BAR Meeting
July 15, 2015

ISSUE: Permit to Demolish/Capsulate, Certificate of Appropriateness and a Waiver of the Rooftop Mechanical Screening Requirement

LOCATION: 1211 Duke Street

2 FRONT ELEVATION
SCALE: 3/16" = 1'-0"

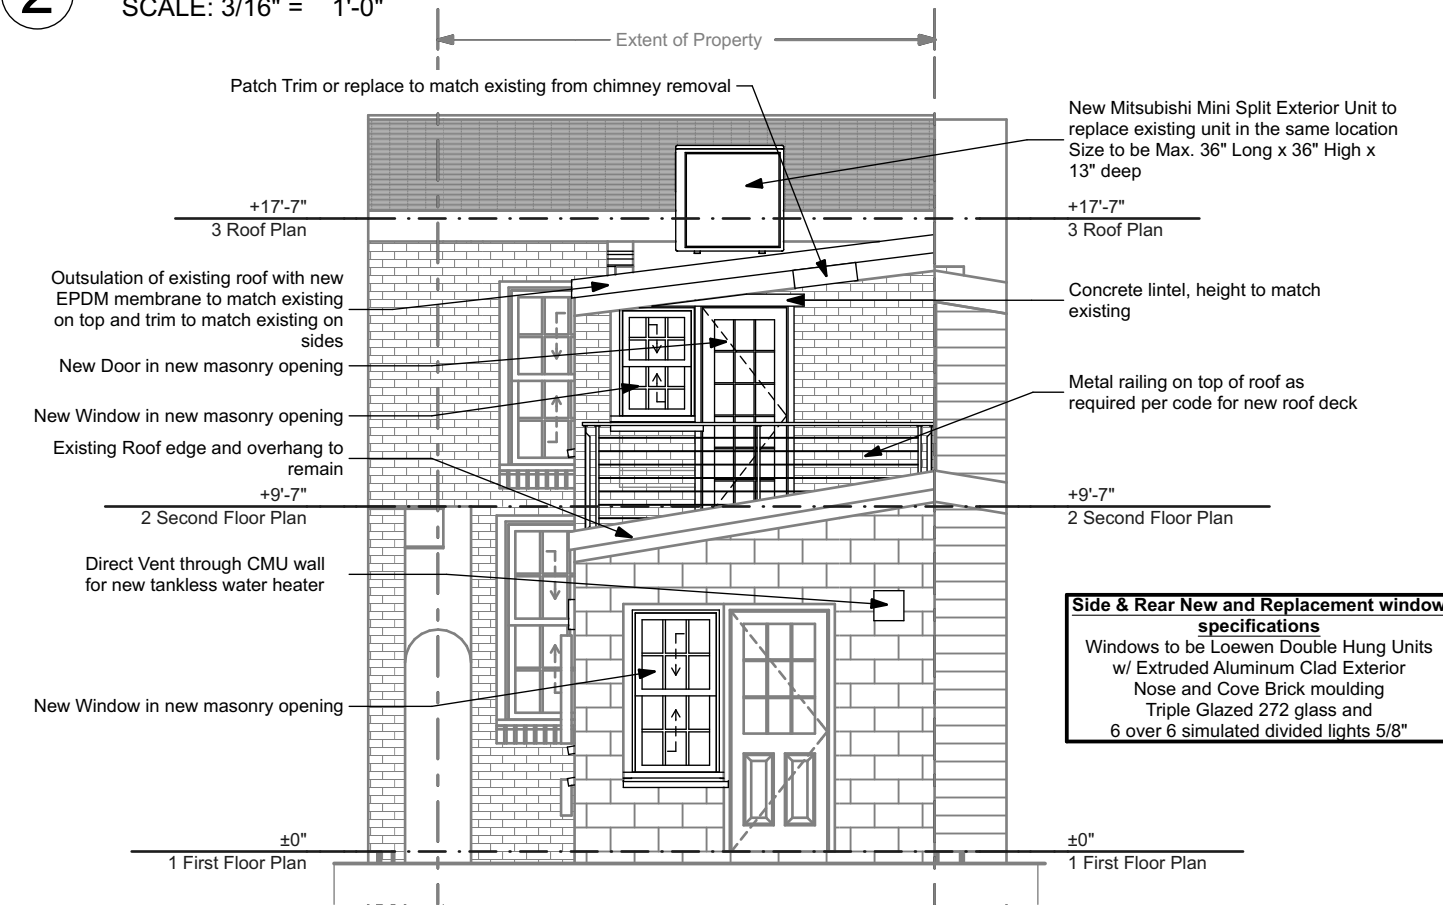
2. That the new wood front door be painted.
3. That the new storm door match the color of the new, painted front door.
4. That the statements in archaeology conditions below appear in the General Notes on all construction drawings that involve demolition or ground disturbance (including Basement/Foundation Plans, Demolition, Erosion and Sediment Control, Grading, Landscaping, Utilities, and Sheeting and Shoring) so that on-site contractors are aware of the requirements.

1 RIGHT ELEVATION
SCALE: 3/16" = 1'-0"

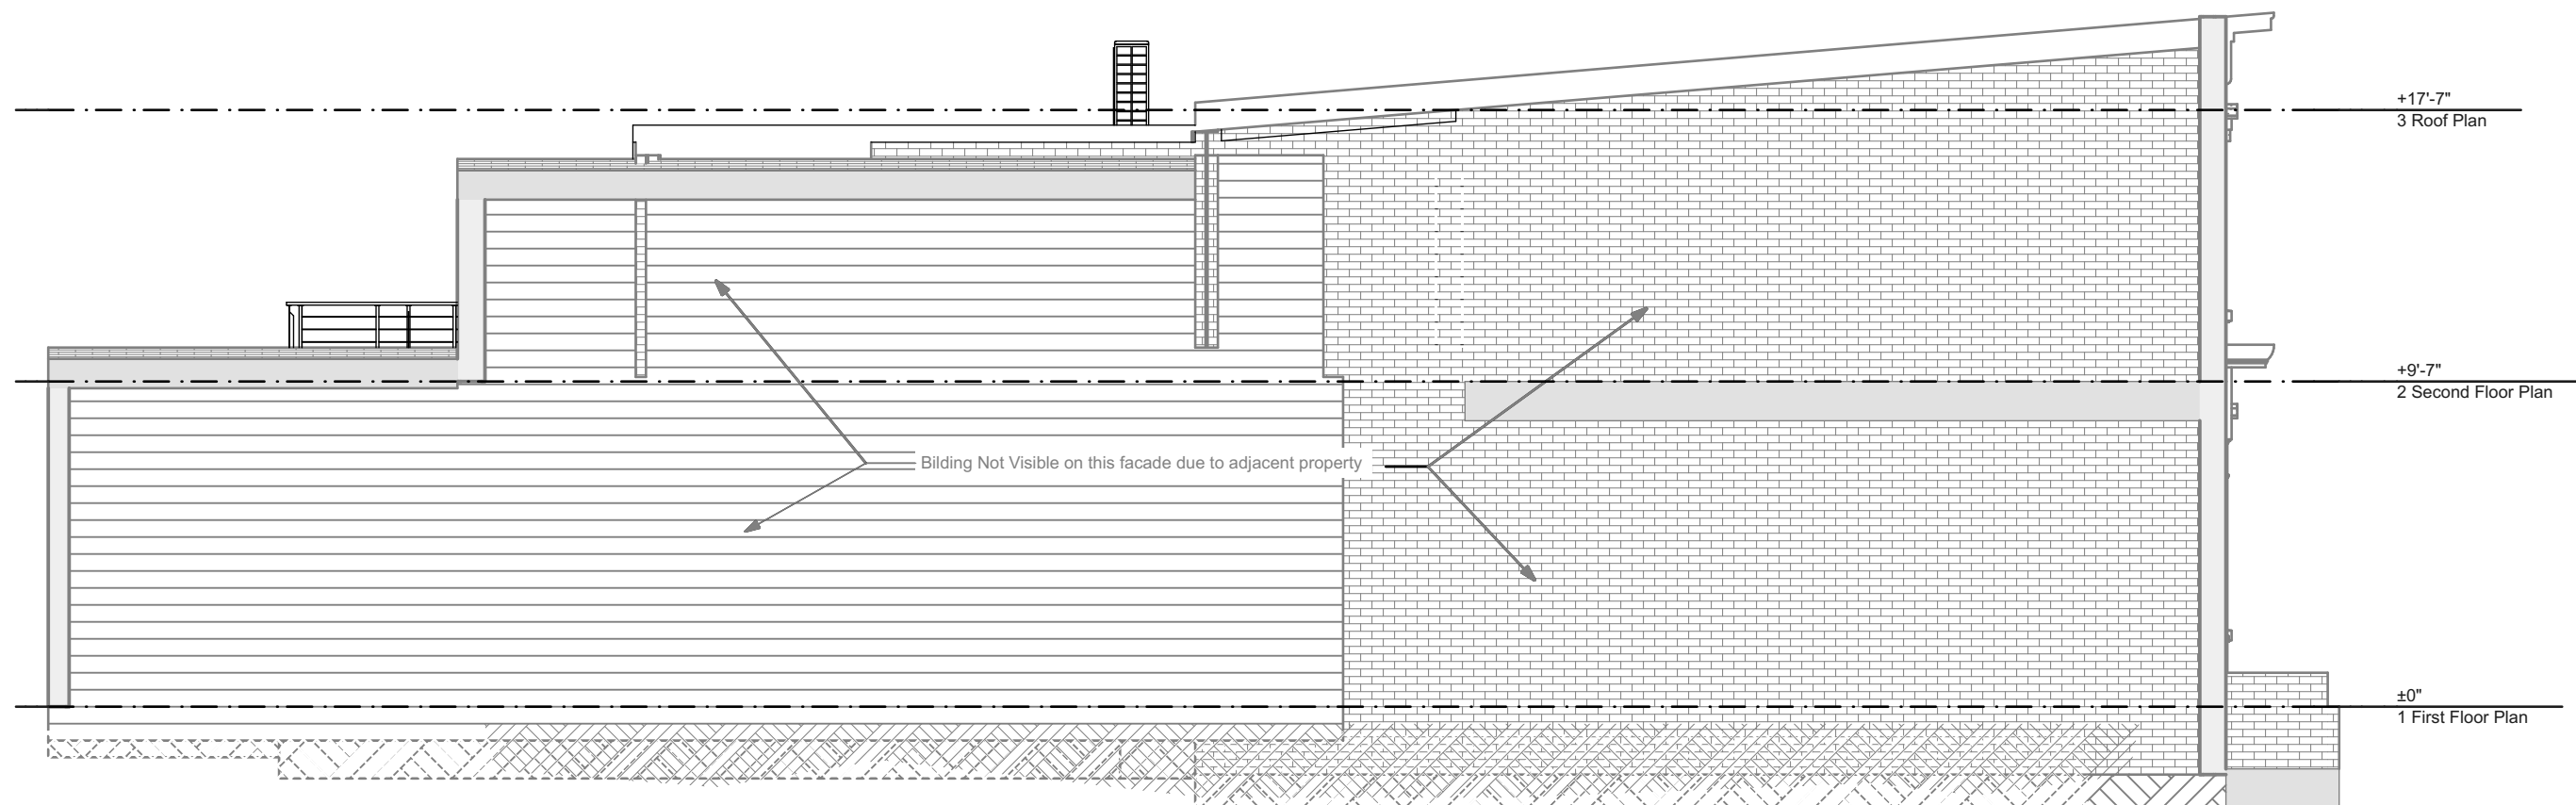
1. That the second floor window on the east elevation either be retained, replaced in the same opening or in-filled with brick and recessed slightly from the wall face. No new window openings or enlarging existing openings are recommended on this elevation.
